Model		NA2 (European & Taiwan versions only)						Volt/Hz	Date of Modification	Serial Number		
Modified Article												
Reason for Modification		To prevent thin white lines										
Draw No.	Old Parts No.		New Parts No.	Description	A.B.C.	Q'ty Used		Inter-change-ability	Part needed for replacement by new part		Parts Catalog	
					Rank	Old	New		Part No.	Description	Index No.	Page
	C2098151			Flat Cable - Main / IPB - 75mm		1	0					
			C2108420	Flat Cable - Main / IPB - 110/220/240V		0	1	X/O			16	85

DETAILS OF MODIFICATION

Model	NA2	Volt/Hz	Date of Modification	Serial Number
Modified Article	Main Board ROM for 4 Languages			
Reason for Modification	At the field's request

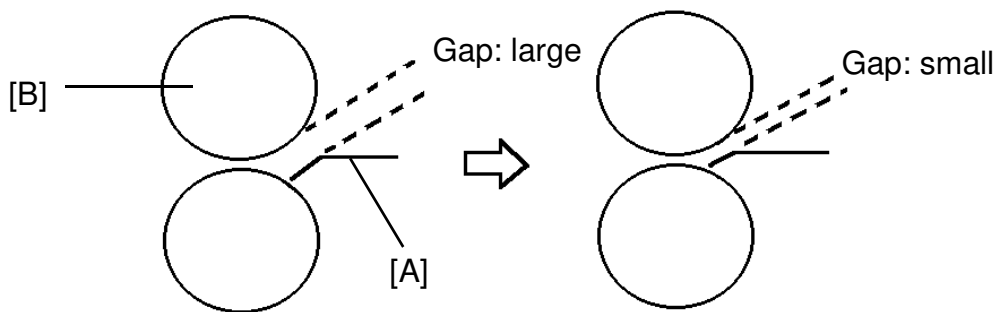
If a machine is used under high temperature and high humidity conditions, the leading edge of the master tends to curl, and sometimes master misfeed might occur.

To minimize master feed jams, the shape of the master guide plate [A] has been changed to reduce the gap between the plate and the upper master feed roller [B].

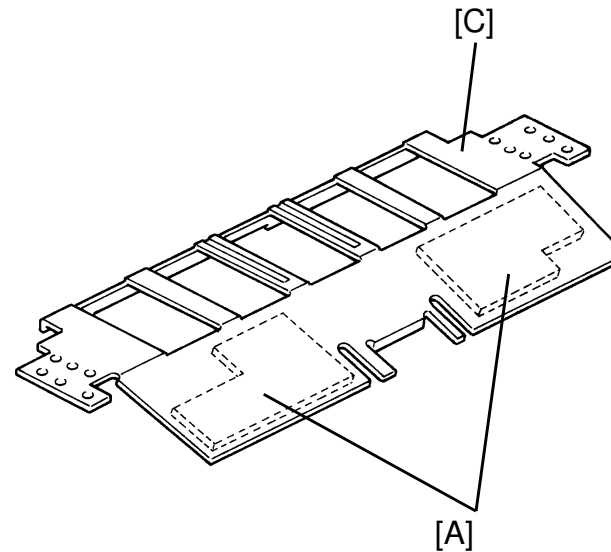
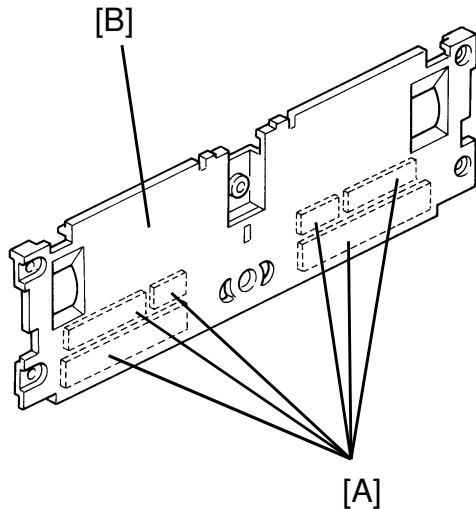
To reduce paper feed noise, vibration absorbing pads [A] have been added to the Paper Entrance Plate [B] and the Lower Paper Guide Plate [C].

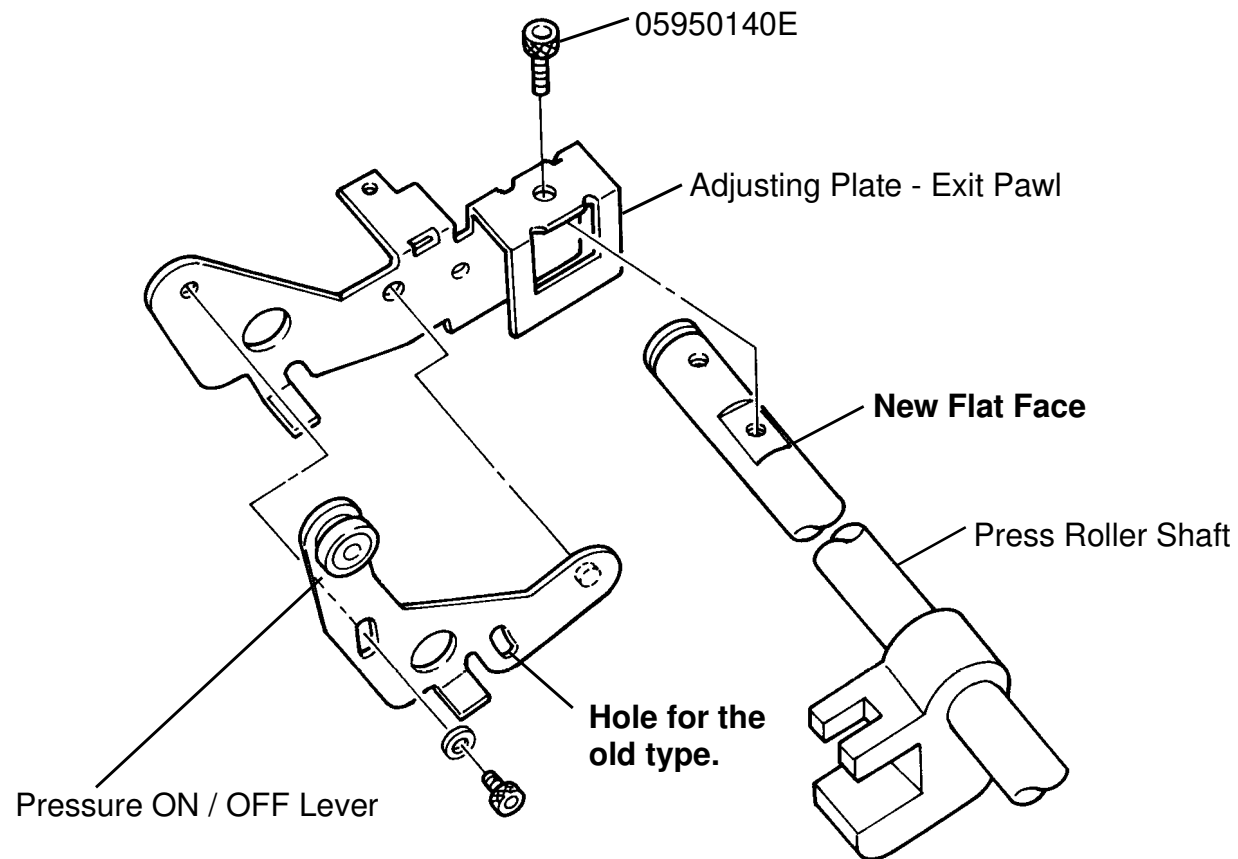
A flat face has been added on the shaft as shown on the next page.

Due to the added flat face on the shaft, the connecting part has been lowered 2 mm.

To ensure that this part is fixed to the adjusting plate in the exact correct position and that it does not move during operation, the distance between the two screw holes has been increased. (The position of the screw holes on the adjusting plate side has also changed.) This part can be installed with the old type adjusting plate because it has a screw hole for the old adjusting plate (C2095570). This part is needed only when the optional A4 drum is used.

Page 19 DRIVE SECTION IIAll versions

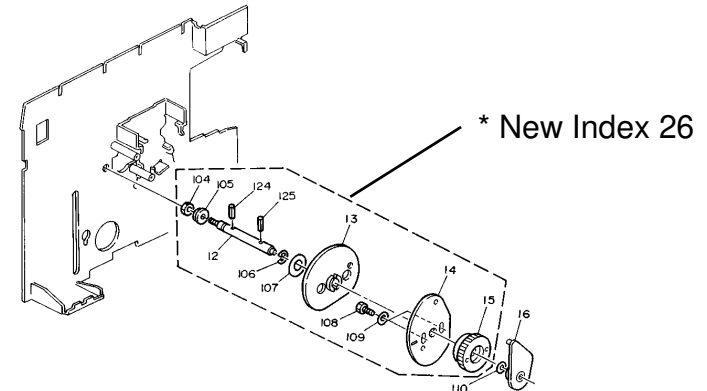
Add the following part and correct the illustration as shown below:

New Index	P/N	Incorrect Description	Q'ty
26	C2095101	Feed Cam Ass'y	1

Page 45 PAPER EXIT SECTION IIIAll versions

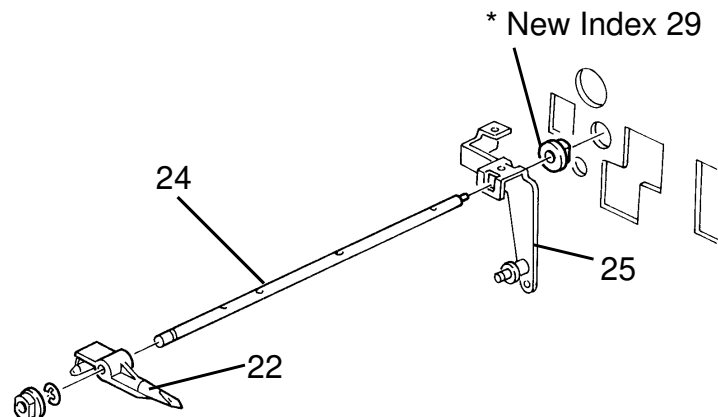
Add the following part and correct the illustration as shown below:

New Index	P/N	Incorrect Description	Q'ty
29	C2032083	Exit Pawl Bushing	1

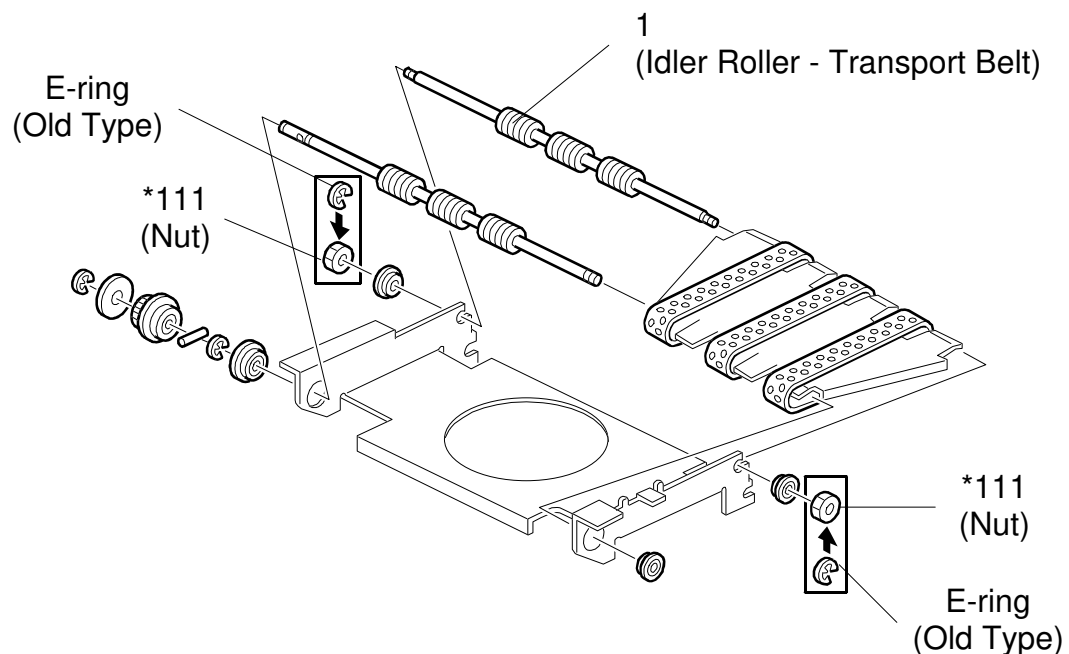
Due to part standardization, the idler roller used in the paper delivery vacuum unit (Idler Roller - Transport Belt) has been modified. Both ends of the roller shaft have been threaded to fit with nuts instead of E-rings (Retaining Ring - M4), as shown below.

NOTE: The new part can only be used in combination with two nuts (#07120060Z).
